## Planning and Zoning Commission Meeting

1. **Call to Order**
2. **[Approve the August 13, 2024, Planning Commission Minutes](#)**
3. **Staff Report**
4. **[Site Plan Review 14601 N. Fairview Drive – Fairview Crossing Townhomes](#)**  
Site Plan Review for 16 four-unit townhomes (64 units) at Fairview Crossing
5. **Adjourn**

STAFF REPORT  
October 1, 2024  
Site Plan Review of Parcel Id # 05-917-00-07-005.00

Application to approve a site plan for the Fairview Townhomes project located within the Fairview Crossing development's Conceptual Overlay Plan. The application includes 16 4-unit townhomes (64 total units) on Lot 1 of the subdivision.

A1

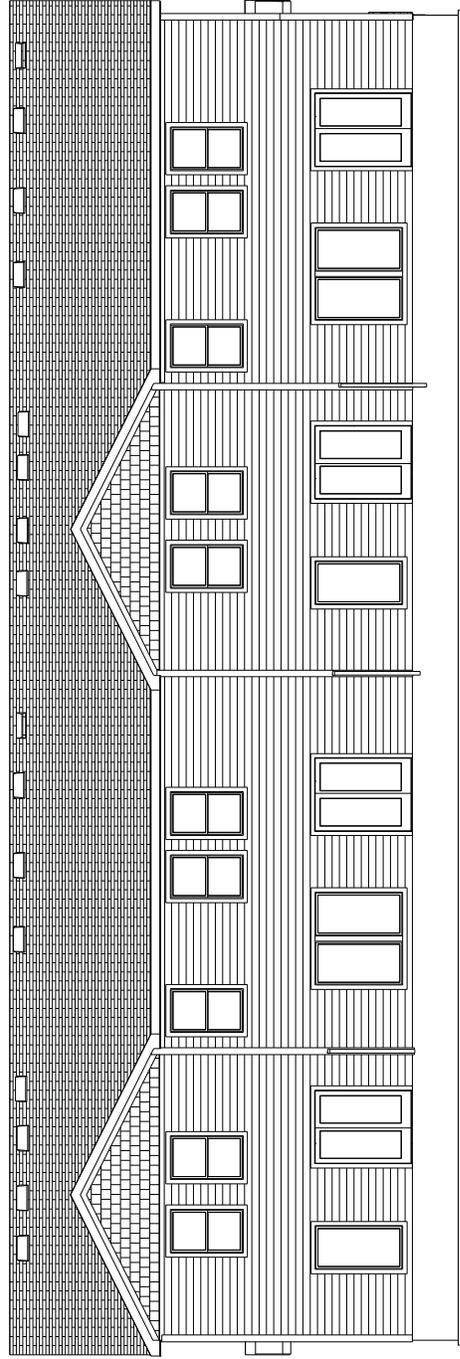
1. Building Materials. The materials used shall meet the intent of this Section by being of such quality, design and type that they will maintain their installed appearance overtime. These materials must be organized in a cohesive development pattern for each of the proposed buildings in the development area. *Exterior facades include LP Siding, Cultured Stone and/or Thin Brick on the front facades, with vinyl siding on sides and rear of buildings. Each building will have a similar design motif with varying complementary colors throughout.*

2. Building Color. Color schemes shall tie building elements together, relate separate (freestanding) buildings within the same development to each other and shall be used to enhance the architectural form of a building. The principal color of all structures shall be generally earth tones, grays and blue-grays or combinations thereof. Intense, bright, black or fluorescent colors must be specifically requested and can only be approved by the Board of Aldermen and in no event shall they be the predominate color on any wall or roof. *Each building will have distinct earth toned color variations that separate and designate each dwelling unit along the rear vinyl sided areas to break up the units. The front façade has multiple materials and colors that enhance the architectural form.*

a. Variation In Massing. A single, large dominant building mass shall be avoided. *The single large massing of the building is eliminated by a combination*

*of different colors of materials for each dwelling unit in the buildings, with gable end treatments added to two of the four units to further distinguish the individual units. The front facades are also broken up with varying colors and materials.*

b. All building walls shall have horizontal and vertical architectural interest and variety to avoid the effect of a single, blank, long or massive wall with no relation to human scale. *The front facades have multiple vertical and horizontal breaks using different materials and the rear is treated with separate color for each unit.*
